Sudden Valley Community Association Architectural Control Committee

Date 05/07/2026

Type of meeting: Request and Plan Review

Front of home

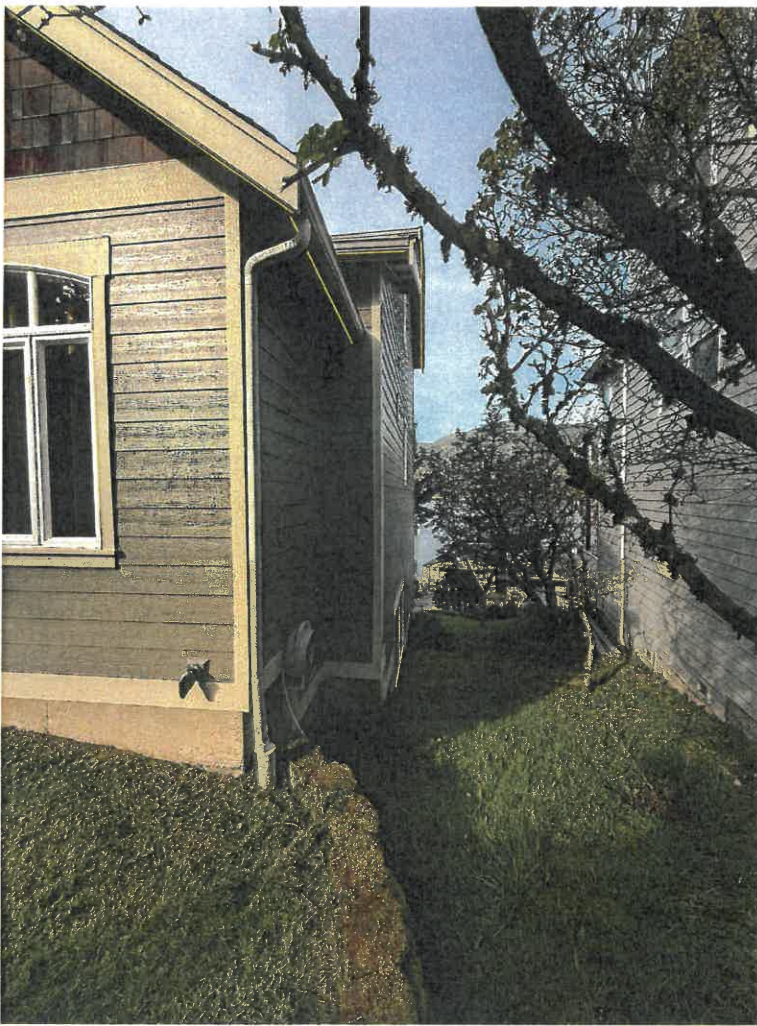
Item - 4	42 North Point Dr, G1, Ext Alt (Lighting)	Video 00:46:32 - 00:55:49
Comments:	Please <u>resubmit</u> your request with the exact deployment of the lights on your home. Please include	
Discussion:	photographs of the home.	
Action:	Denied	Motion: Dan Unanimous

EXISTING CONDITIONS TOPO

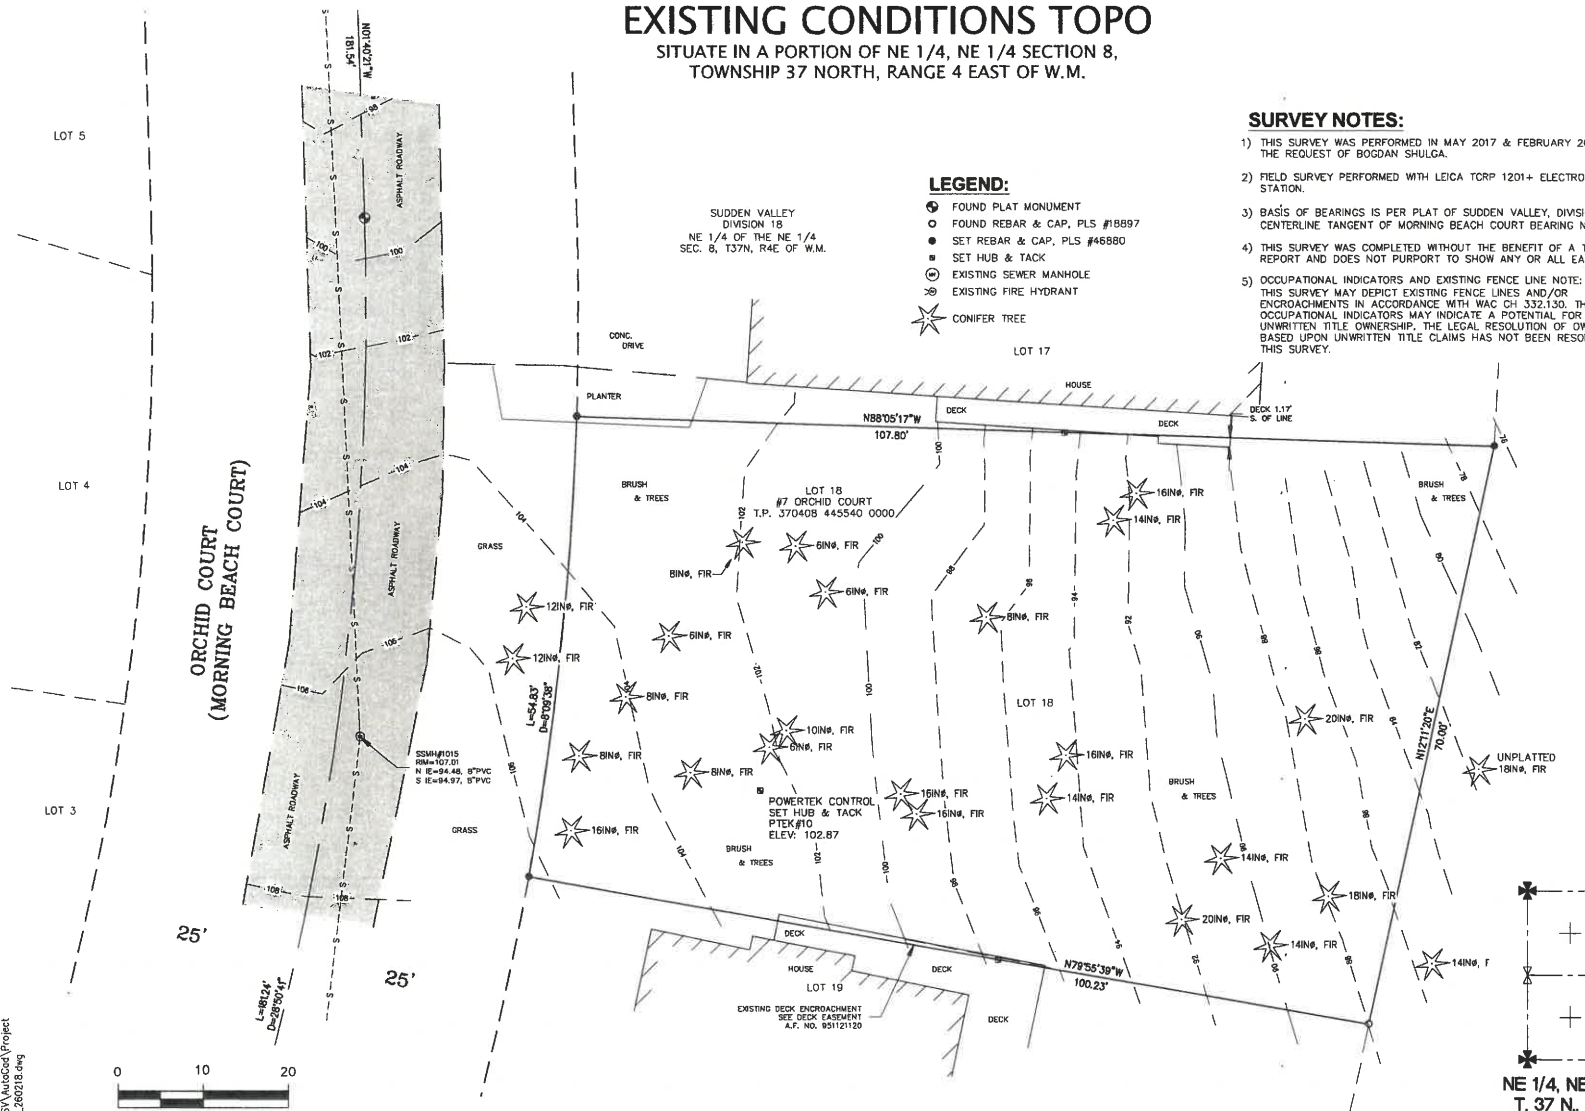
Item – 9	7 Orchid Ct, G2, New Construction <i>In-Concept Resubmission</i>		Video 00:15:56 – 00:22:25
Comments:	Replace the Boxwood trees in the landscape plan with other native trees.		
Discussion:			
Action:	Approved	Motion: Dan	Unanimous
